**WATER & SANITARY SEWER PLAN**

**CITY OF ADDISON, TEXAS**

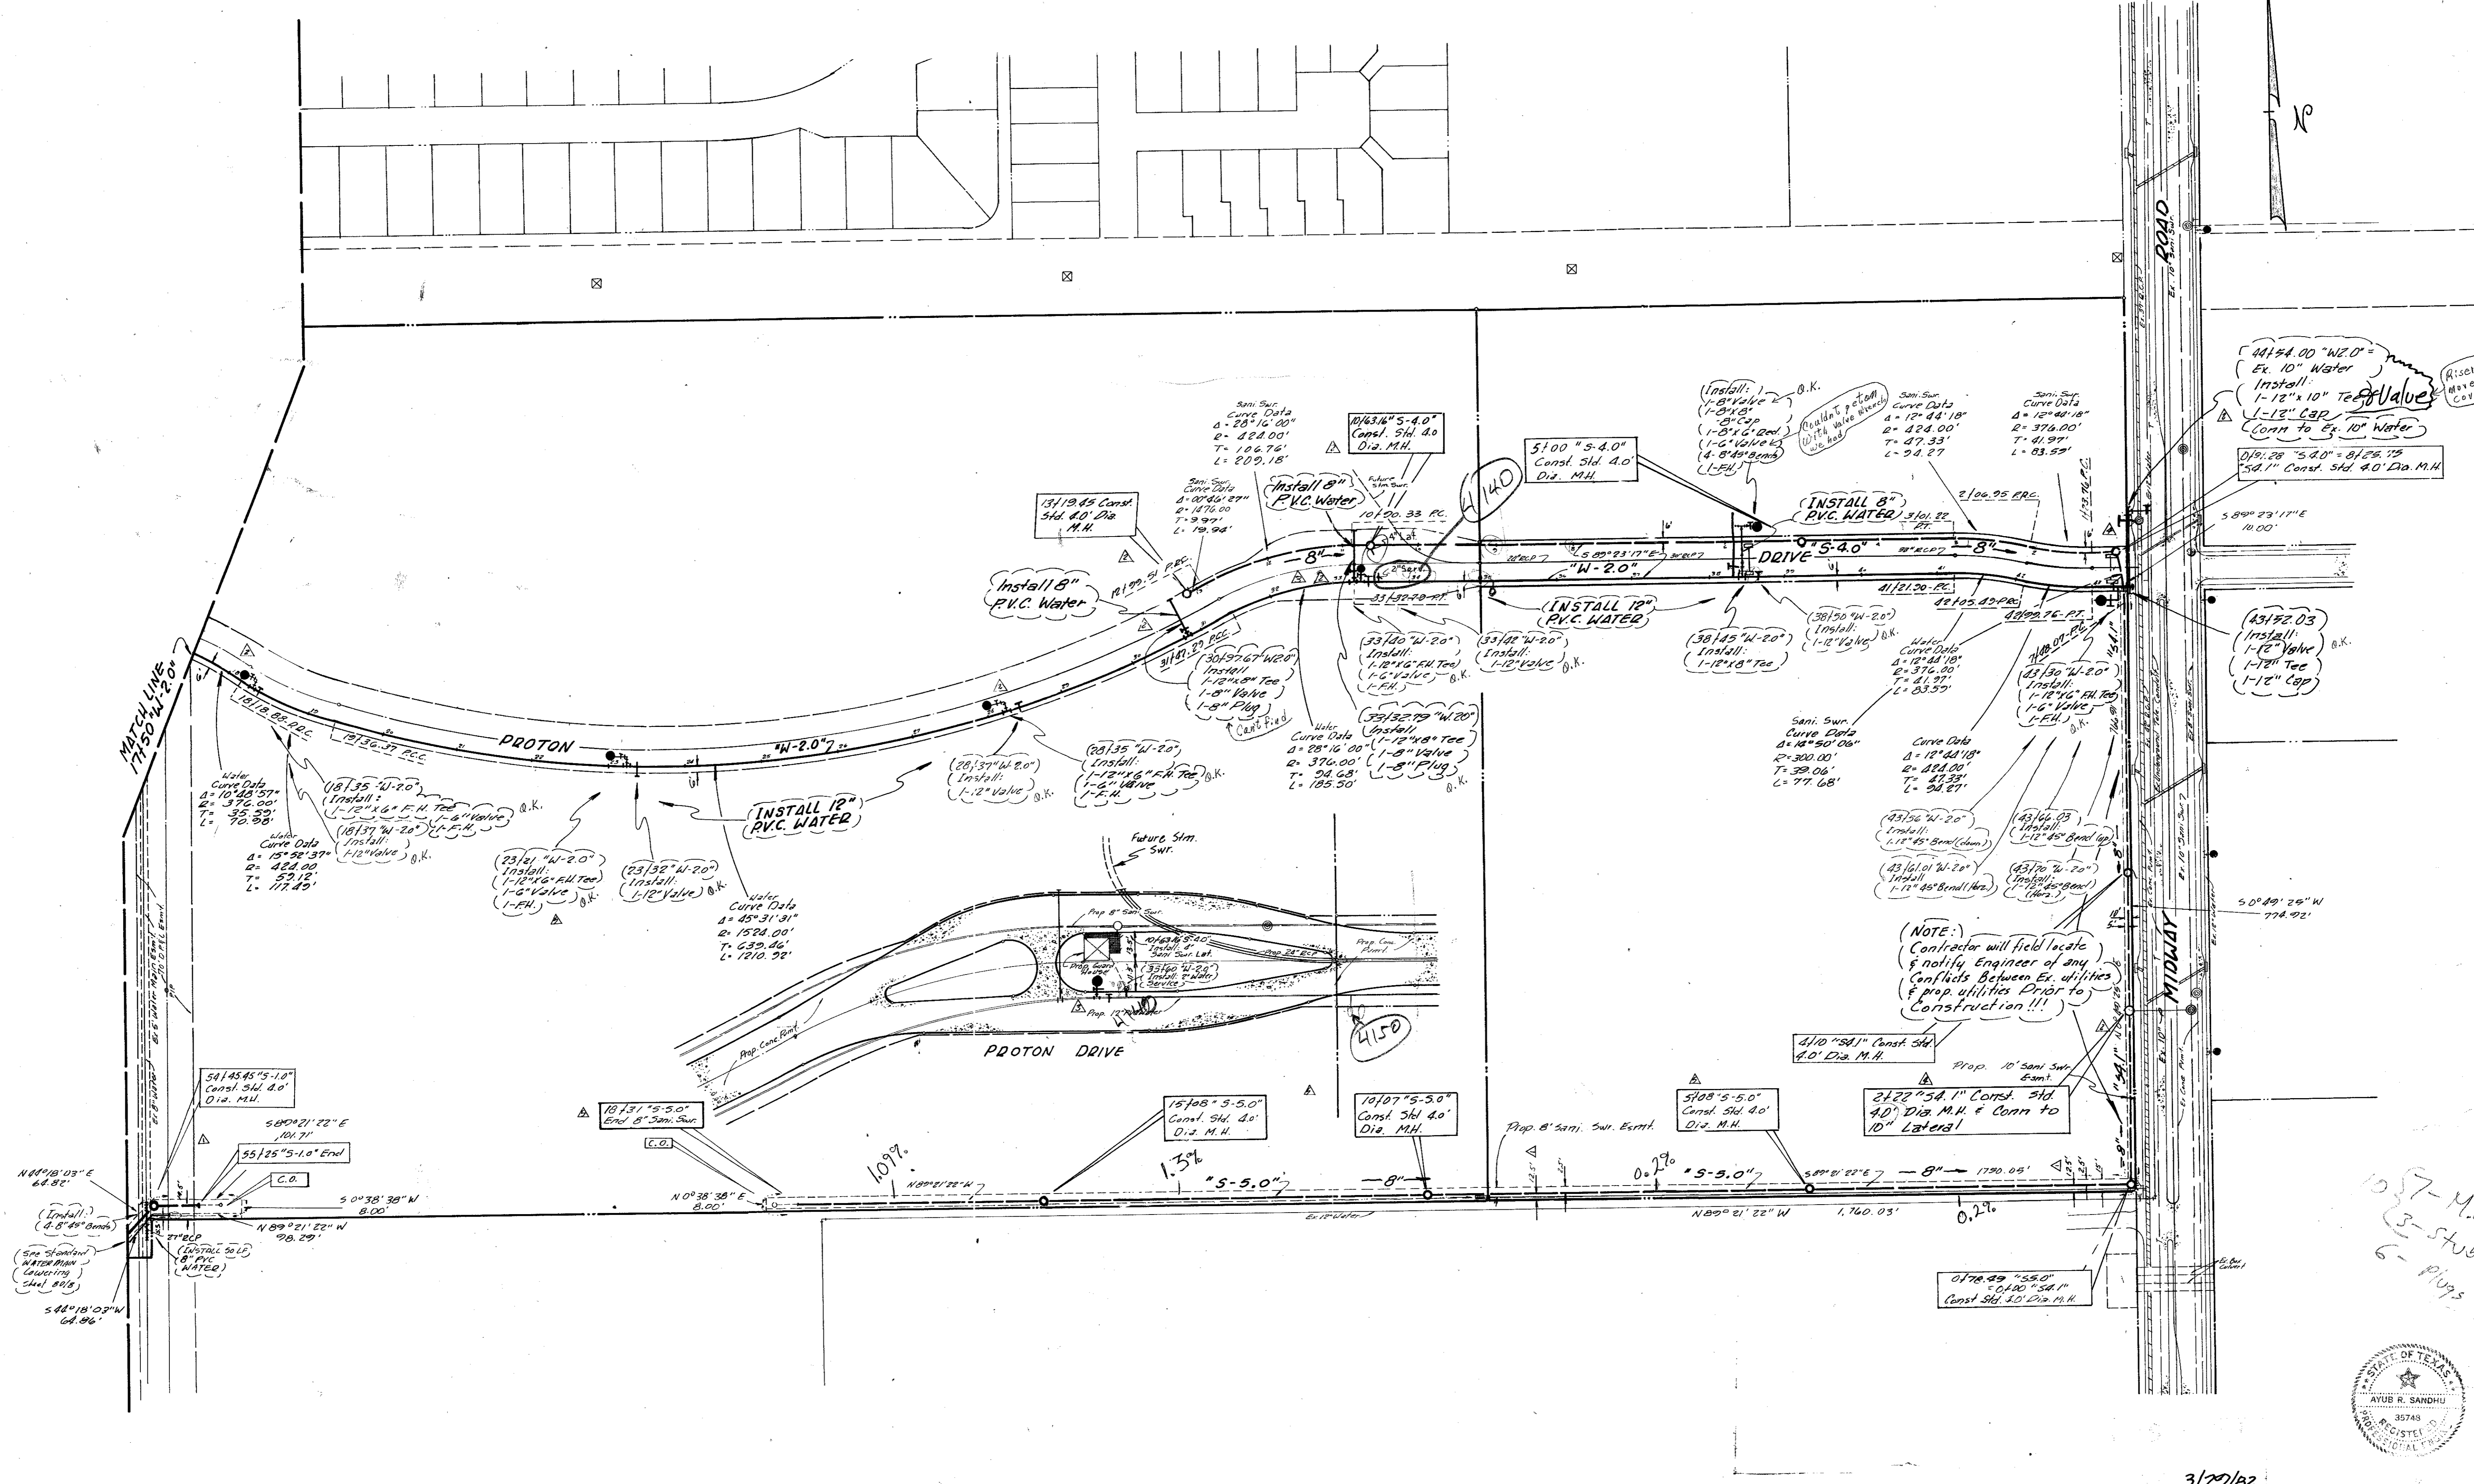
- 9-30-01 Revised Location "S-5.0" (310)
- 11-23-01 Revised FH Stationing 35 & 26/36
- Added 8" Service 30157.676 33132.779
- Deleted C.O. Sta. 13410 "S4.0"
- Add M.H. 13412.45
- Added Line "S4.1"
- 12/10/01 Revised Guard House Utilities
- 2/10/02 Revised Changed Water Line "W2.0"
- Added M.H. Line "S4.1"
- 3/29/02 Revised As Per As Buills
